Proposed Toilet Facilities, Royal Engineer's
Complex, (H 30 A and H 30 B).

KAVHA and Report 8 part II

June 1982

Commonwealth Department of
Transport and Construction.

H30 A ROYAL ENGINEER'S OFFICE, ROOM 4.

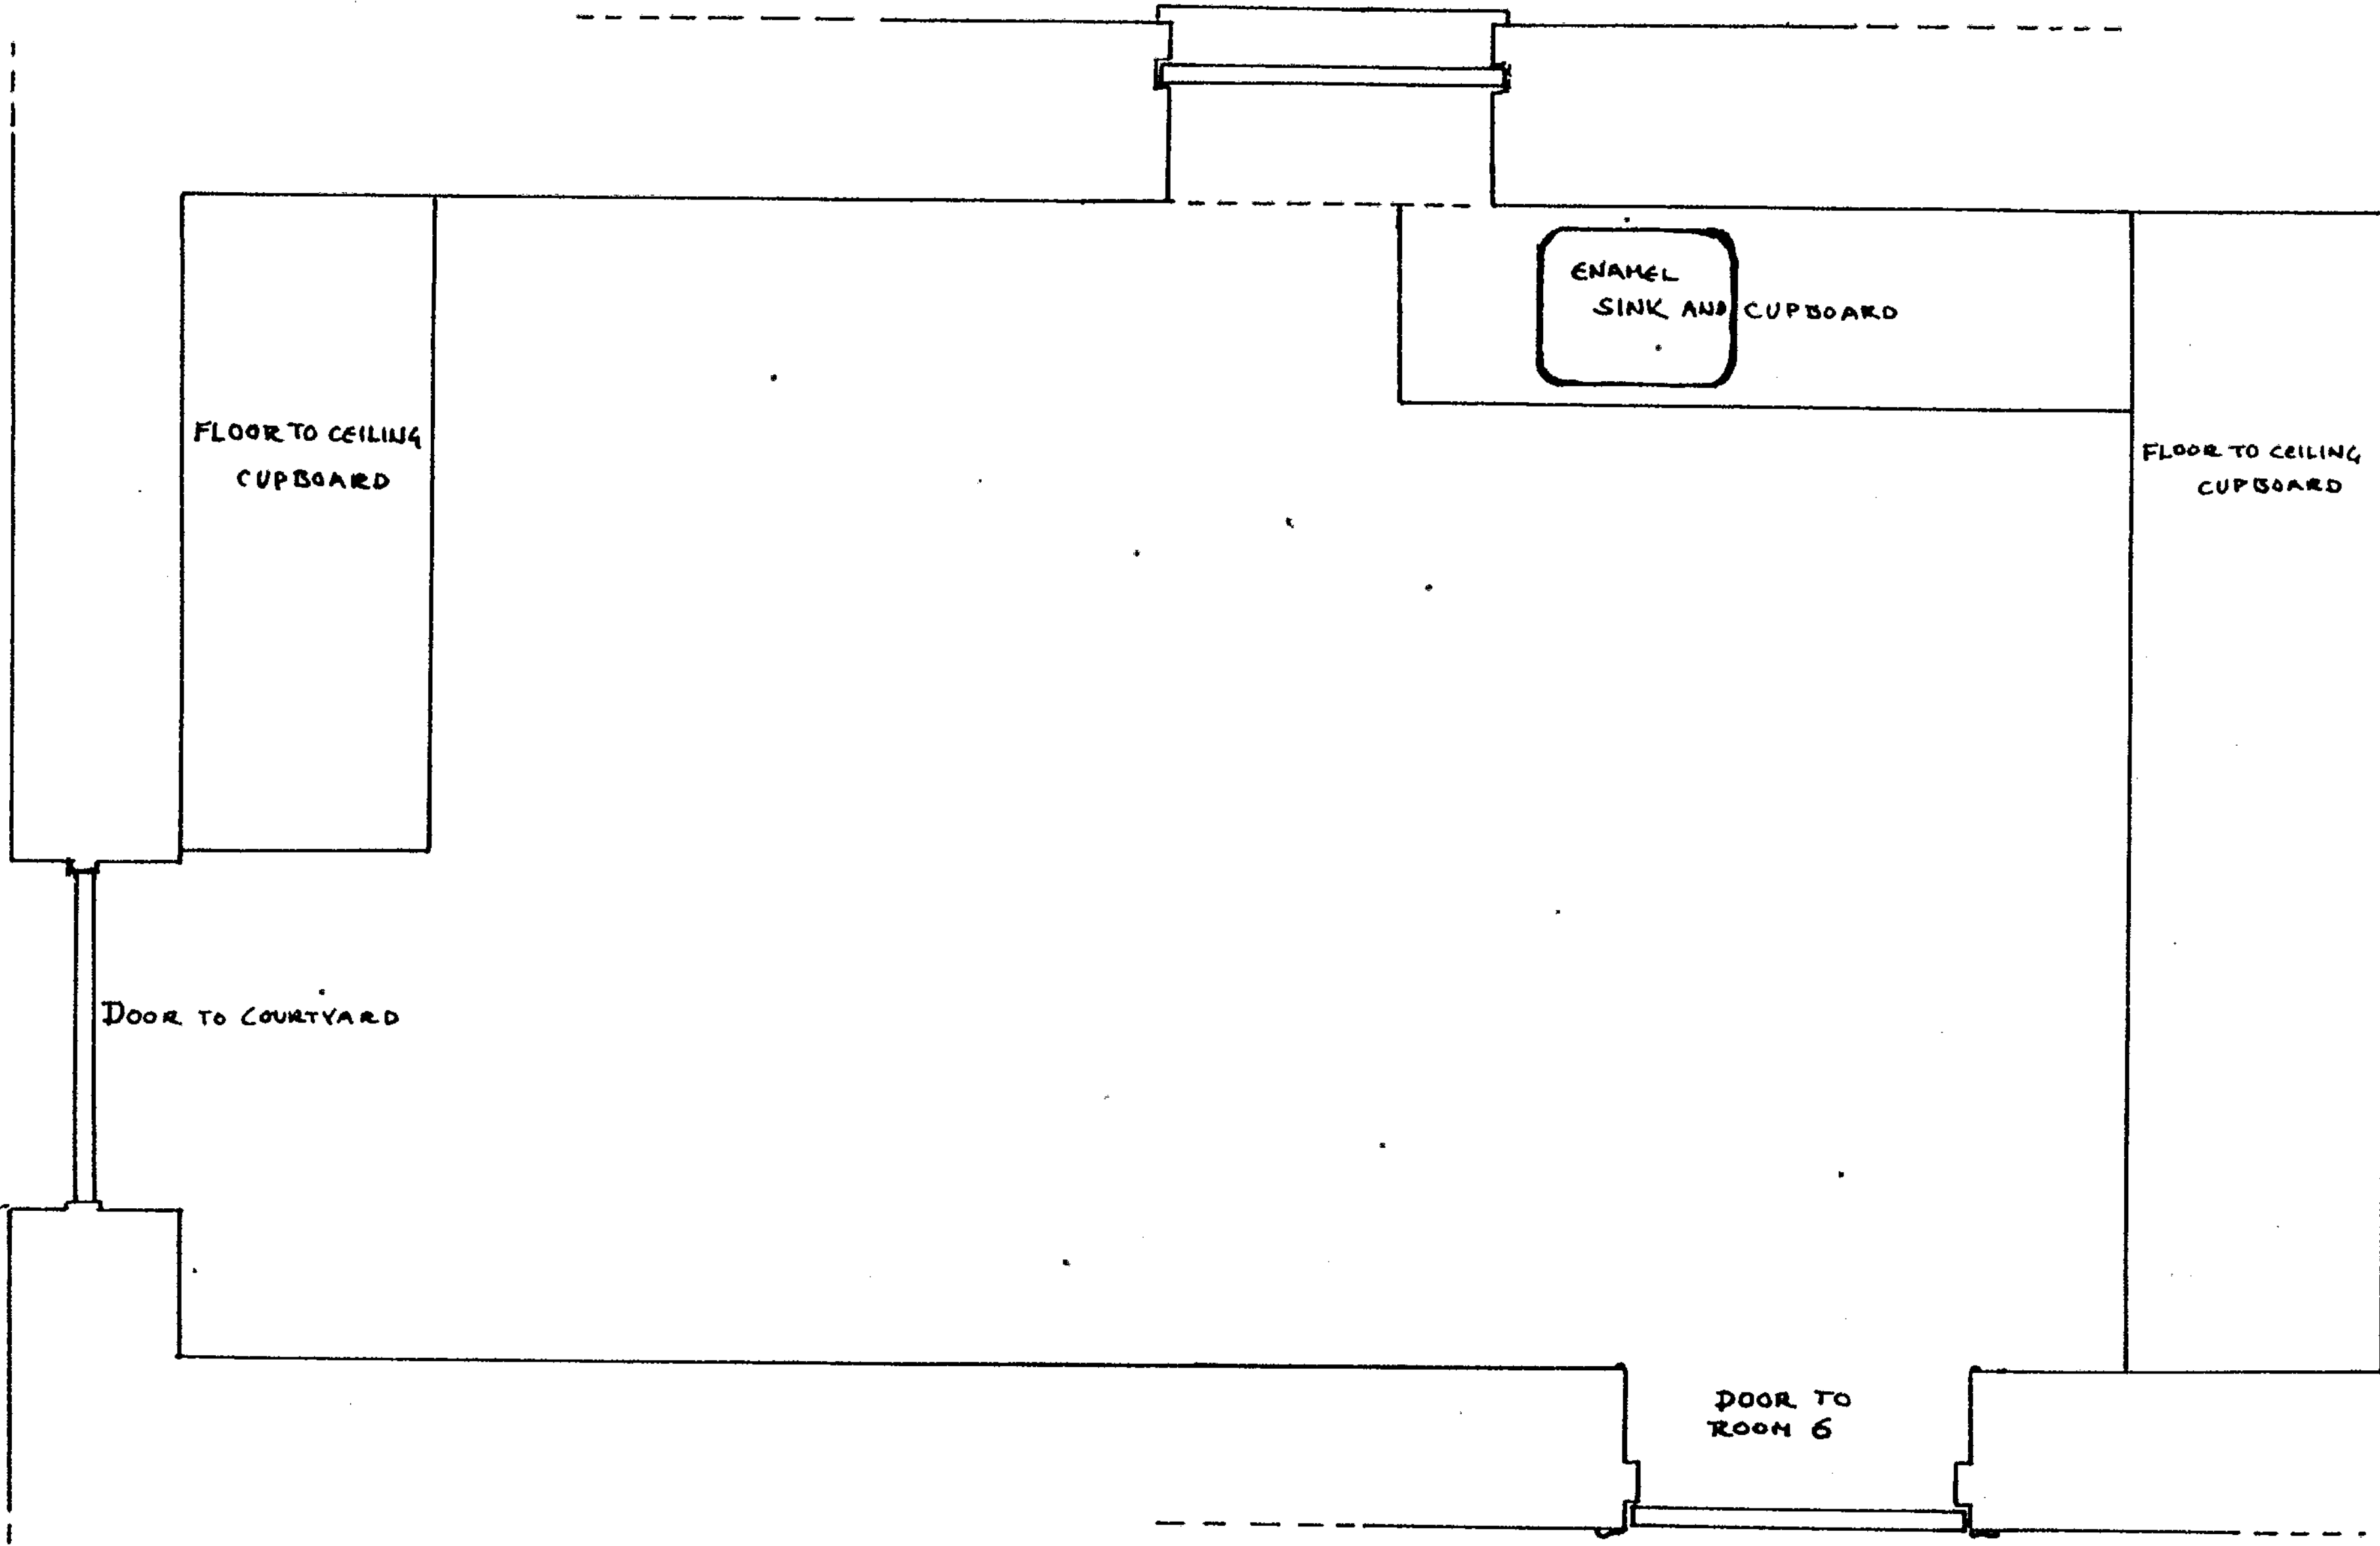
The cupboards are of timber and are built onto the timber wall cladding. These date to the installation of the cladding. The position of the cupboards may be seen in ill. 1.

2:4 Under no circumstances should a door be installed in place of the window as such action would contravene the letter and the spirit of the Management Plan and the Burra Charter, (ie, destroying the fabric and character of the area).

3:2 Under no circumstances should a door be created in the east wall of room 4.

3:3 The architraving and jambs of the western wall door should remain in situ. There would be no objection to the sealing up of the door aperture as long as the action is reversible.

3:4 As the window aperture is of recent origin, as are the sashes and enframements, there would be no objection to the closing of the aperture. The aperture should not be enlarged.
